Design Verification

Ginna Station

Containment Foundation Mat Analysis

EWR #5327

PAL2 MODEL

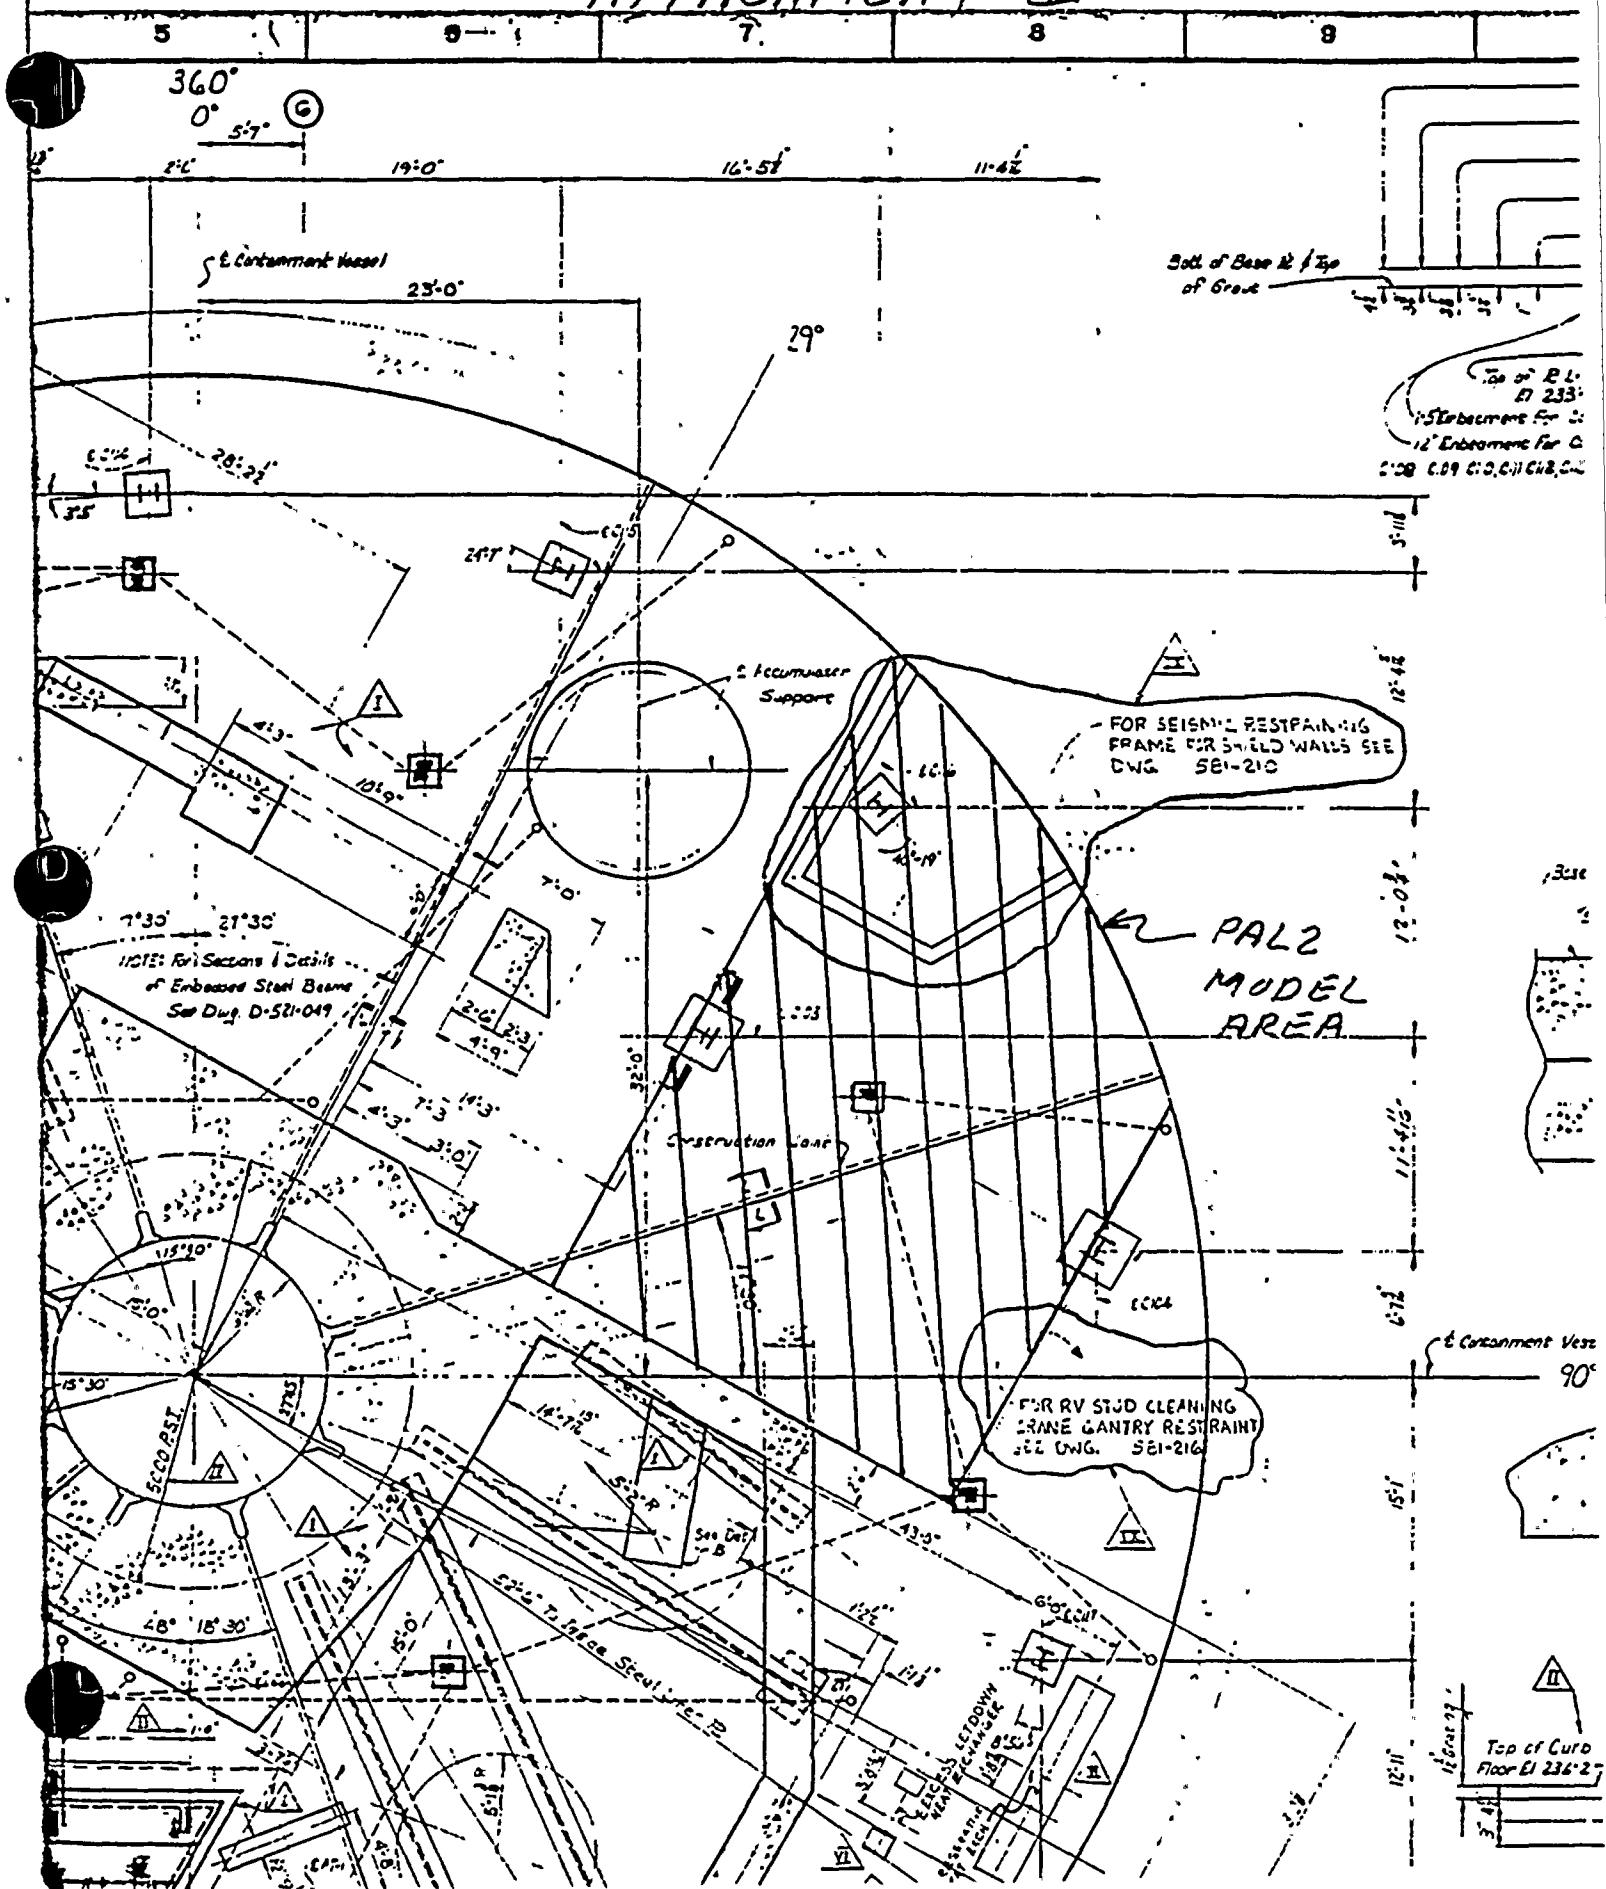
AS A VERIFICATION OF THE  
STARDYNE MODEL AN INDEPENDENT  
ANALYSIS OF A PORTION OF THE  
FOUNDATION SLAB WILL BE  
CHECKED WITH MSC PAL2. (SEE  
ATTACHMENT 1). AN UPWARD  
PRESSURE OF 16.6 PSI WILL BE  
APPLIED. THE VERTICAL DEAD  
LOAD OF COLUMNS C103 AND  
C104 WILL ALSO BE IMPOSED.

MAXIMUM STRESS = 934 PSI ELEM. 17

PERMISSIBLE STRESS = 1277 PSI

SLAB IS ADEQUATE FOR INCREASED  
GROUND WATER LEVEL.
